**OVERALL SITE PLAN**

**EAGLE SPRINGS GOLF COURSE MAINTENANCE FACILITY**

WALTON COUNTY, FLORIDA

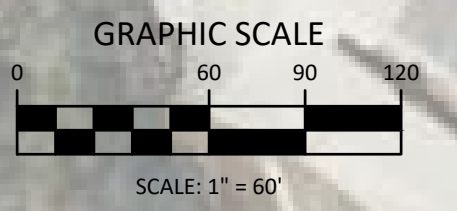
THE PROPOSED IMPROVEMENTS HAVE THIS CONCRETE PAD BEING REMOVED, AND WATER CAPPED/ABANDONED

THERE IS A UNITI FIBER BOX HERE. THIS BOX WAS NOT LOCATED ON THE SURVEY. IT DOES NOT SEEM THE PROPOSED IMPROVEMENTS/GRADING WOULD IMPACT IT.

RE-ROUTED CART PATH DUE TO LIVE OAK ROAD EXTENSION CONSTRUCTION

TEE BOX WOULD BE REMOVED
